Access Compliance Report

Public Rights-of-Way

(Curb Ramps)

Intersection ID: 11058	Main Street: N_I-77_EXIT_10B_RA	Cross Street: N_I-77_EXIT_10C_RA	Location: S
ADA ID: 916DEE795BD0	Ramp Type: Para	Initial Pass/Fail: Fail	Overall Compliance: No
Severity Score: 12.5			
Codes/Mitigation Info/Possible Solution		Field Measurements/Component Compliance

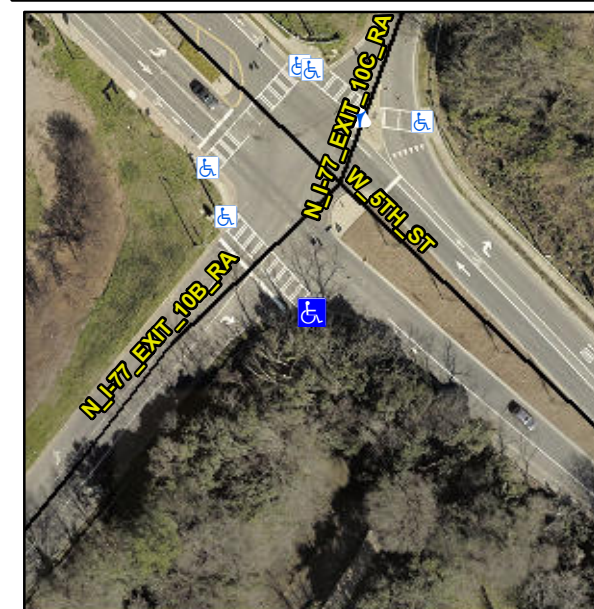
Surveyor Notes:

RT RP < 5%

PROW/ADA:

R304.3.2

Possible Solutions:

Remove & Replace Entire Ramp.
